**AGENDA**  
**Special Session**  
**THE PLANNING AND ZONING COMMISSION**  
**TOWN OF CAMP VERDE 473 S. MAIN STREET**  
**CAMP VERDE, AZ. 86322**  
**COUNCIL CHAMBERS STE. 106**  
**THURSDAY MARCH 10, 2016**  
**6:30 PM**

6. **Public Hearing, Discussion and recommendation to Council for (approval/or denial) of an (exception/waiver) requested by the applicant and owner, John Bassous (Tierra Verde Holdings, LLC), to the Town of Camp Verde Engineering Standard 512D requirements (Road Development Standards) for the proposed Castle Heights subdivision as located on assessor parcel number 404-18-181E and is adjacent to Arena Del Loma. (This is part of the Preliminary Plat approval process as outlined in the Town of Camp Verde's Planning & Zoning Ordinance, Section 505) – Resource: Community Development Director Michael Jenkins**

7. **Public Hearing, Discussion and recommendation to Council for (approval/or denial) of an (exception/waiver) request by the applicant and owner, John Bassous (Tierra Verde Holdings, LLC), to the adequate fire flow requirements for the proposed Castle Heights subdivision as located on assessor parcel number 404-18-181E and is adjacent to Arena Del Loma. (This

SHEET 1 OF 2

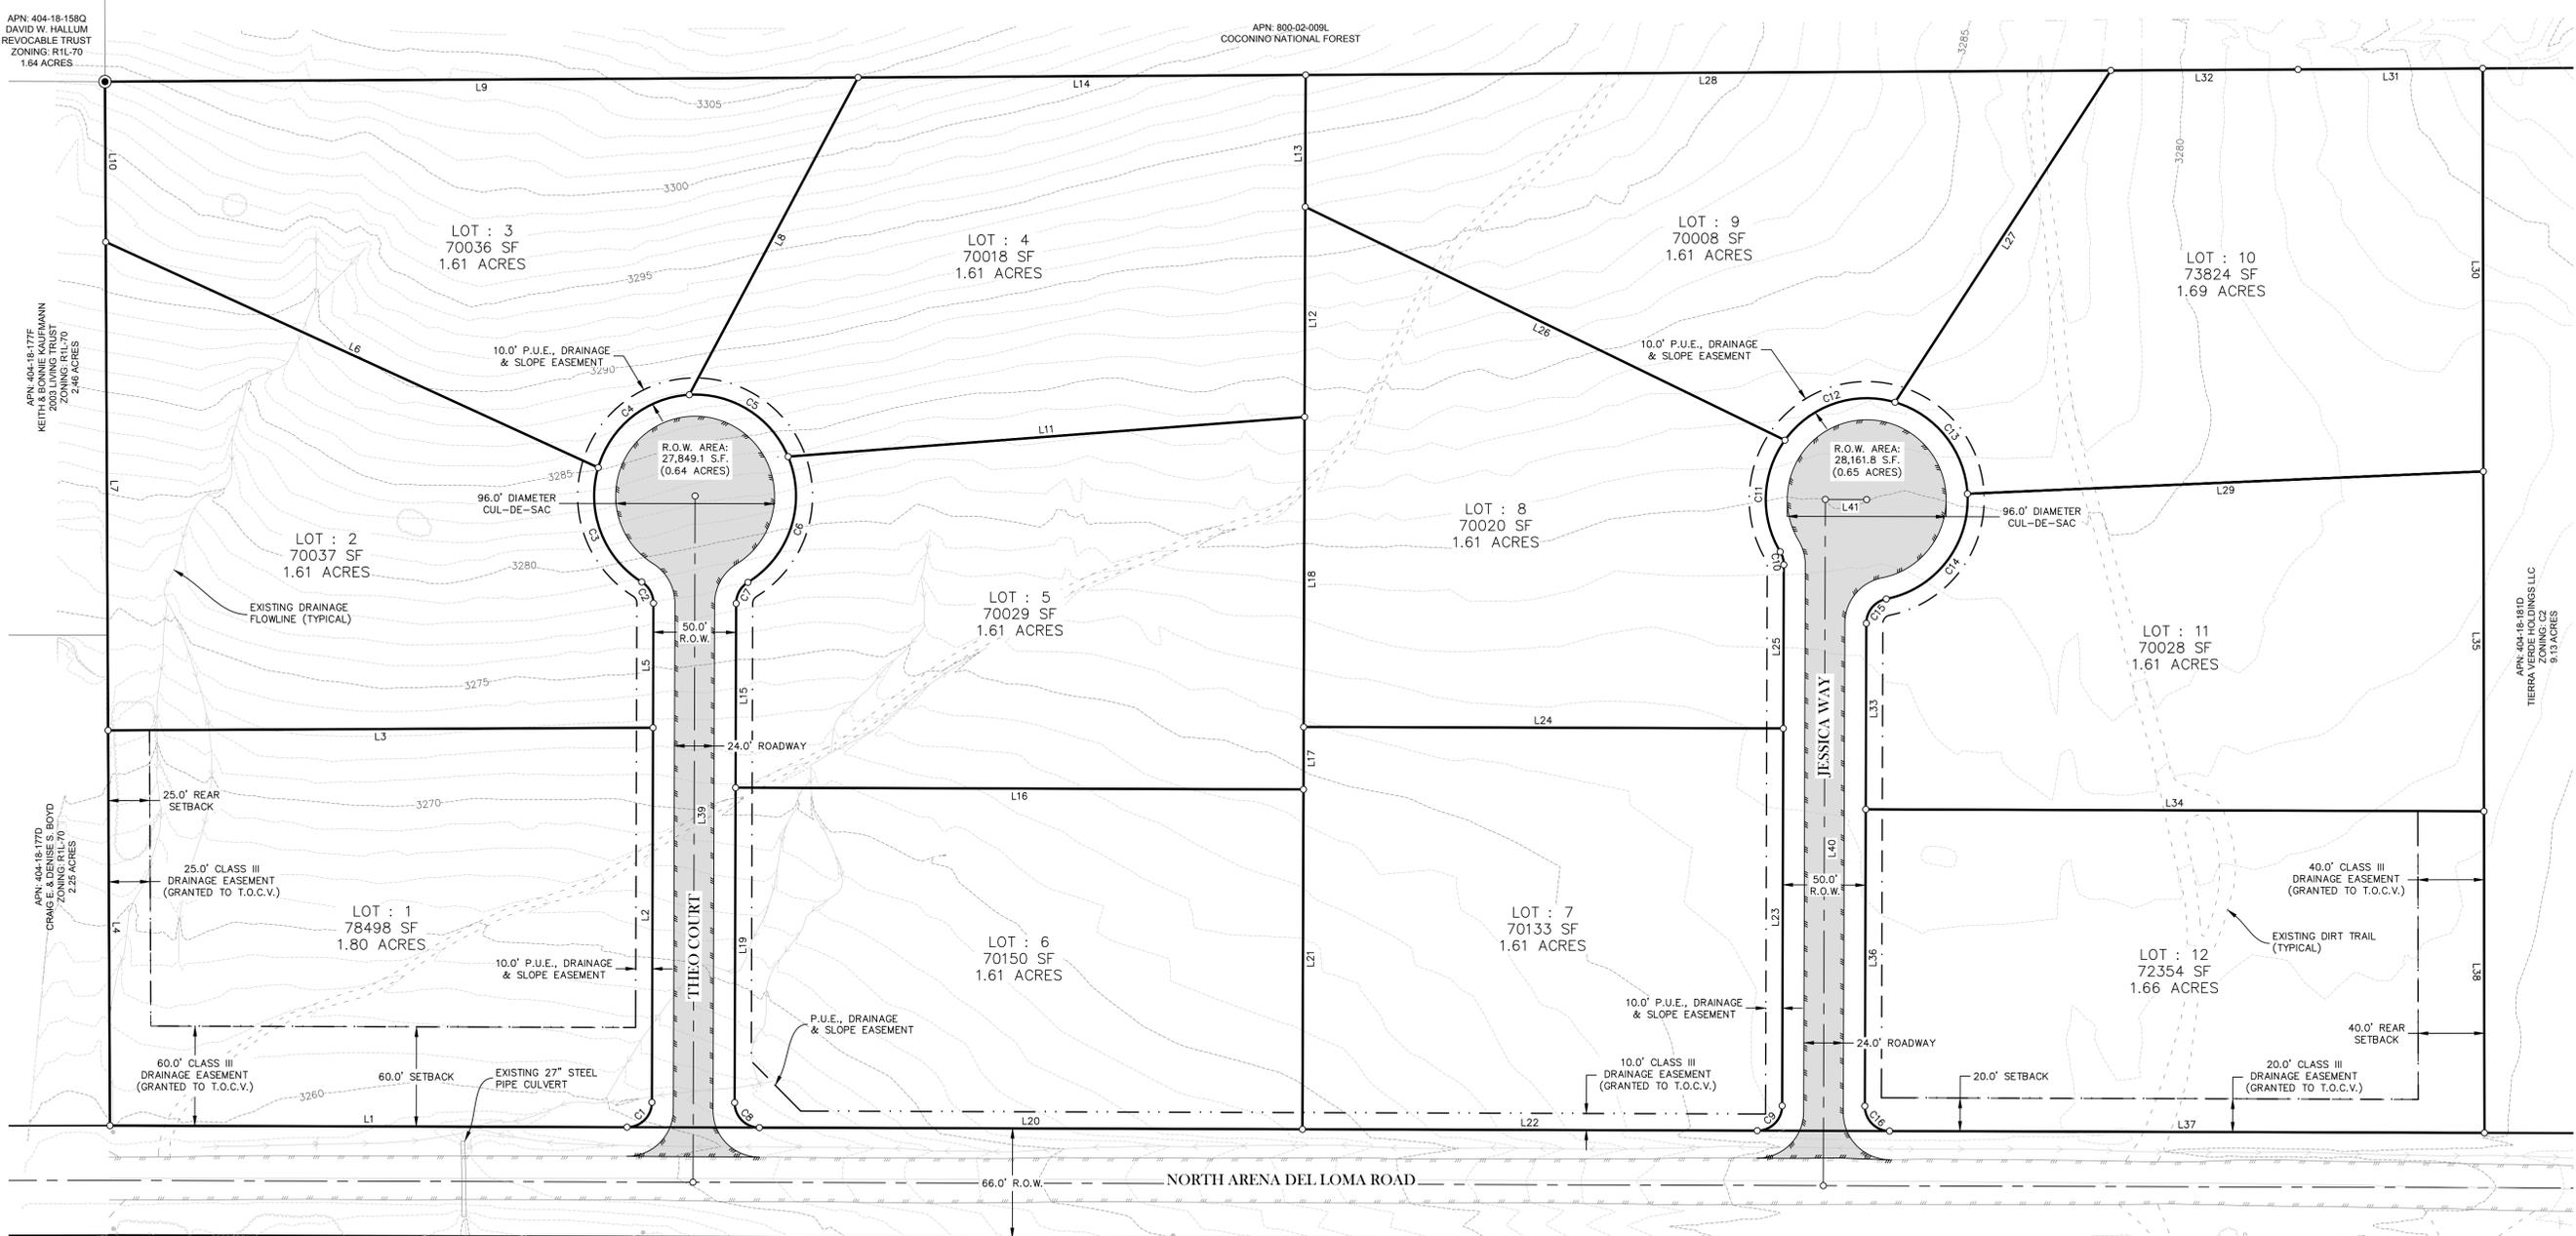
8. Lot Layout: Including minimum building setback lines related to all streets; typical lot dimensions (scaled); dimensions of all corner lots and lots on curvilinear sections of street; each lot numbered individually and total number of lots shown.  
This requirement has been addressed. The current zoning of parcel 404-18-181E is R1L-70. R1L-70 indicates a minimum lot area of 70,000 square feet. The smallest lot indicated on the preliminary plat is 70,008 square feet. Per the current Planning & Zoning Ordinance Minimum Front Yard Setback is 20', Minimum Rear Yard Setback is 25', Minimum Side Yard Interior Setback is 7', and Minimum Side Yard Exterior Setback is 10'. The applicant should note that the "Site Data" listed on the Preliminary Plat indicates parcel "Portion of Assessor Parcel Number 404-18-181D" and should be revised to reflect the current parcel number "404-18-181E".

TYPICAL ROADWAY SECTION NO SCALE

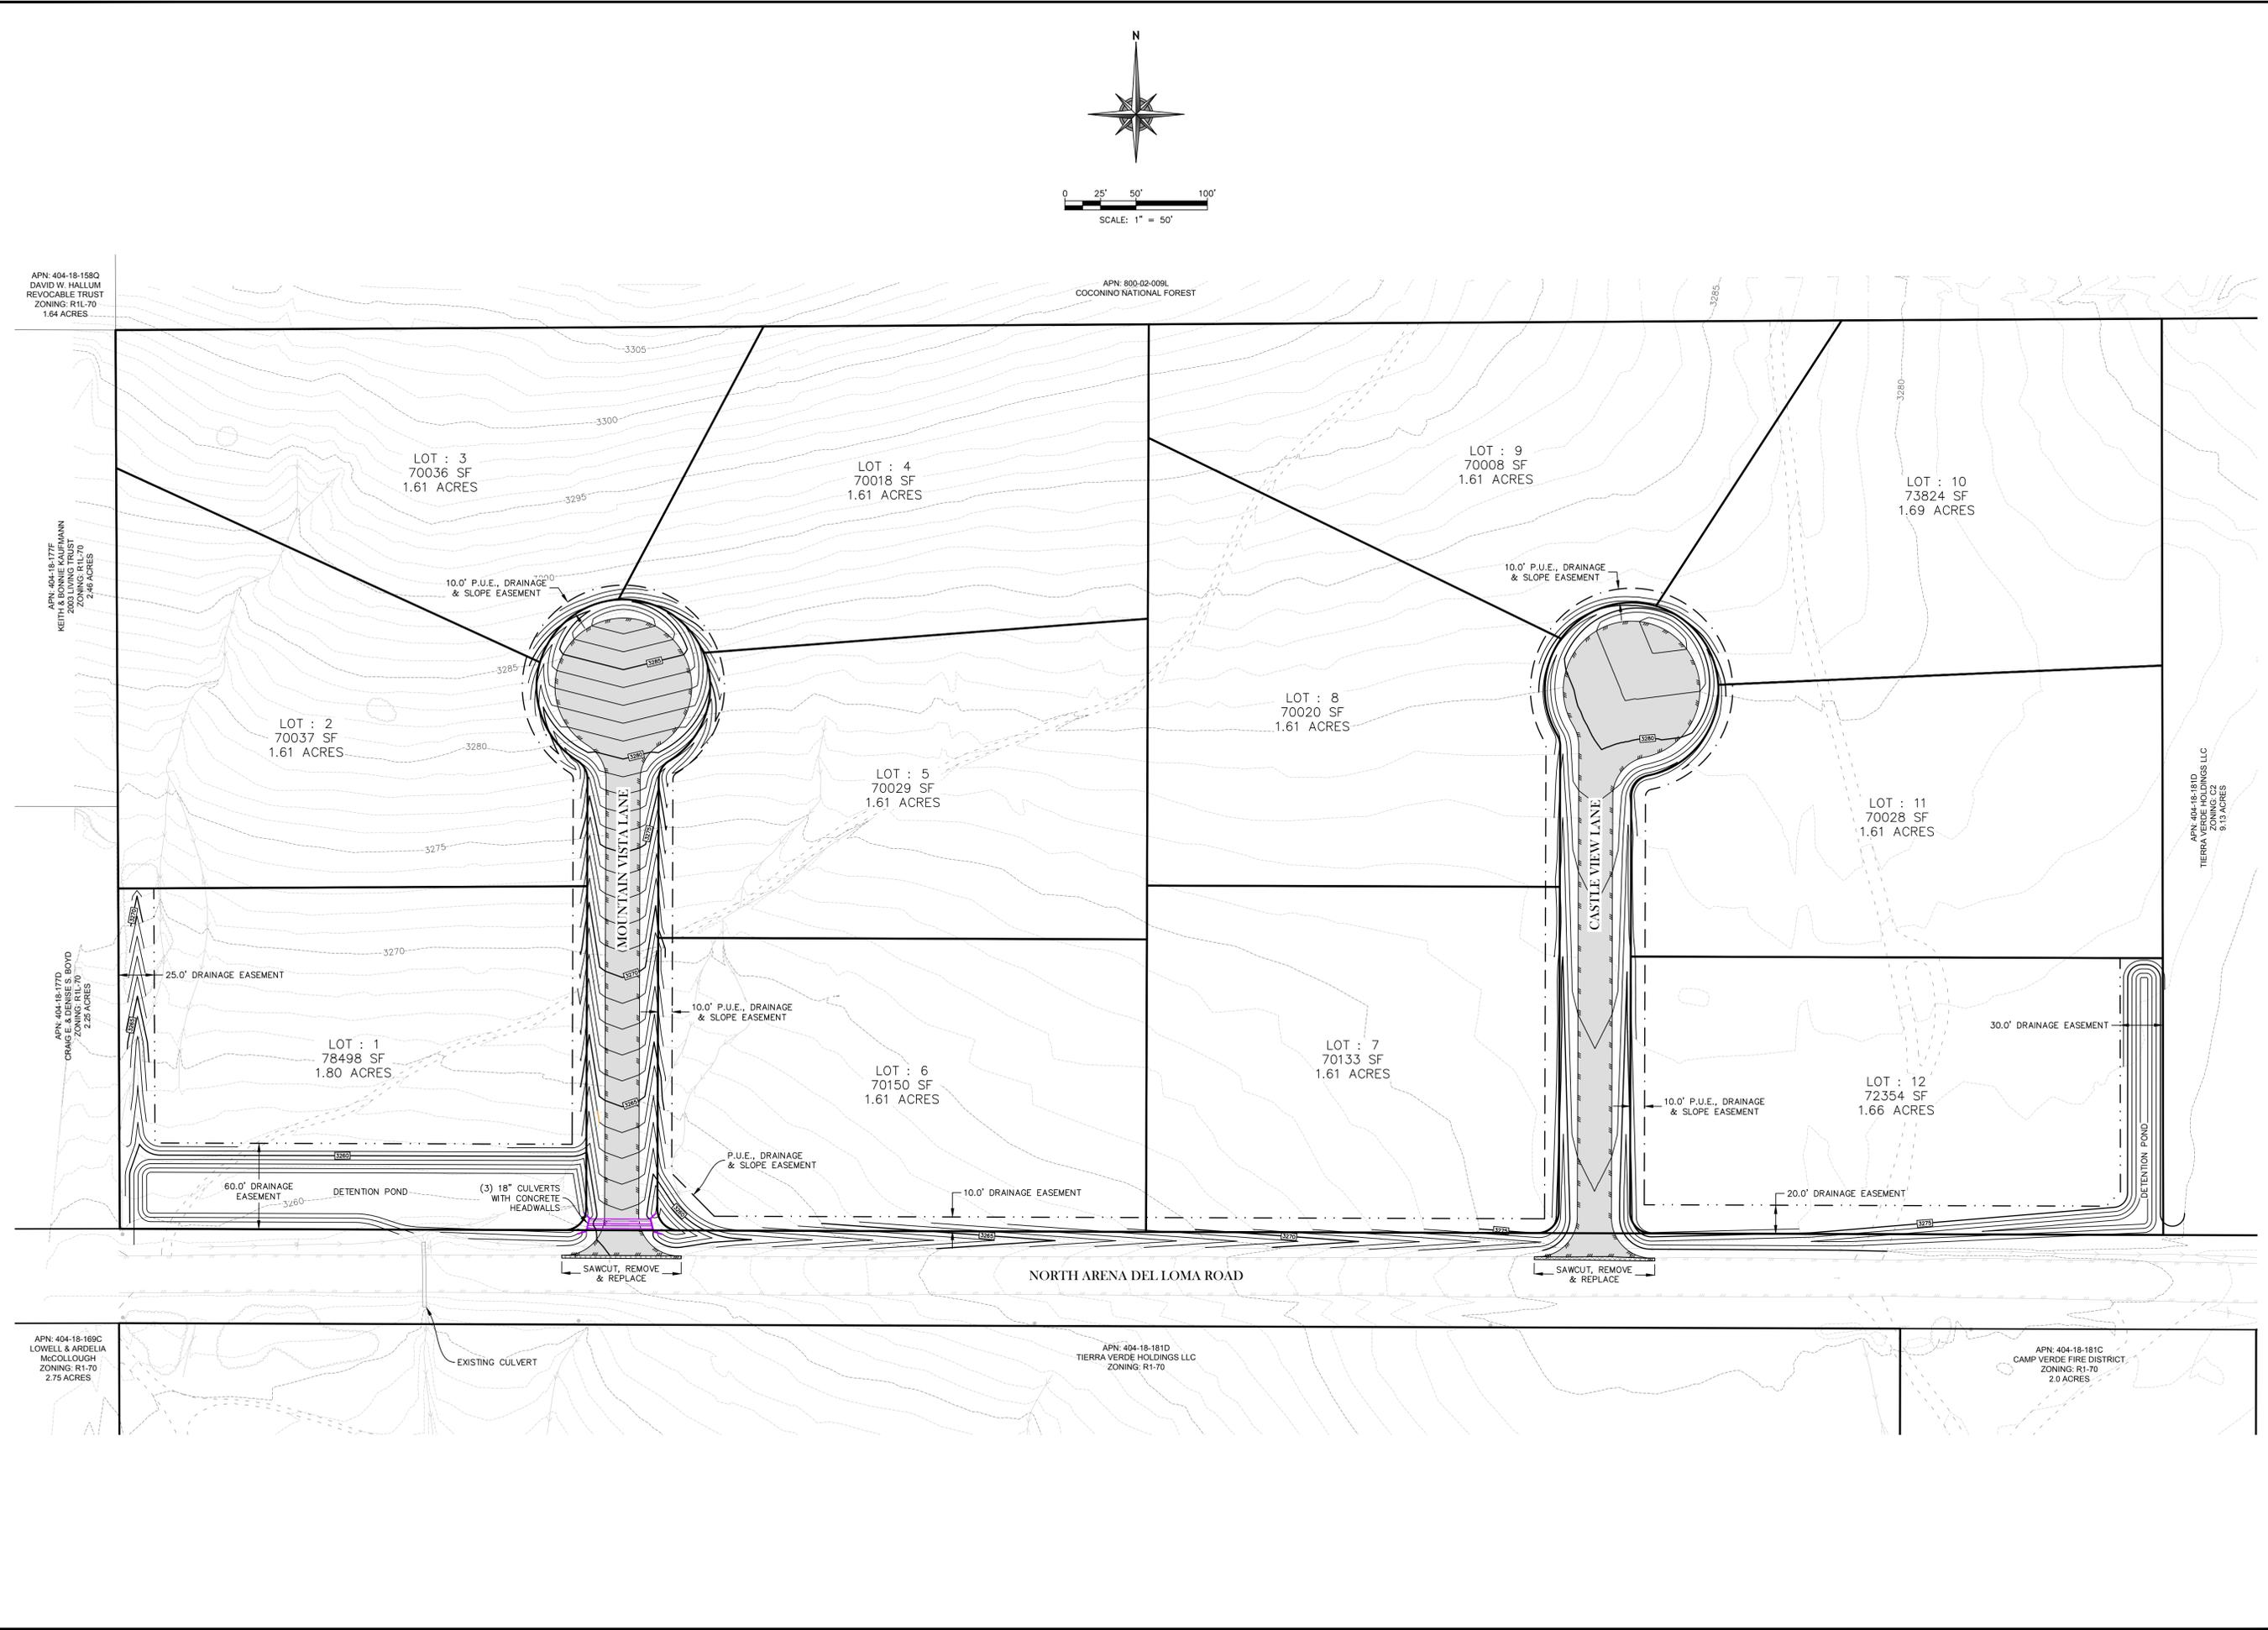
8. Provide a "Estimated Quantities Section" for the Improvements.
9. Revise the "Typical Roadway Section" detail to reference the MAG Std. Dtl 201 Type A for the thickened edge section.

Also add a note to the detail for the roadway structural section to be 3" AC over 9" AB per the Town of Camp Verde Engineering Standards Section 512D.
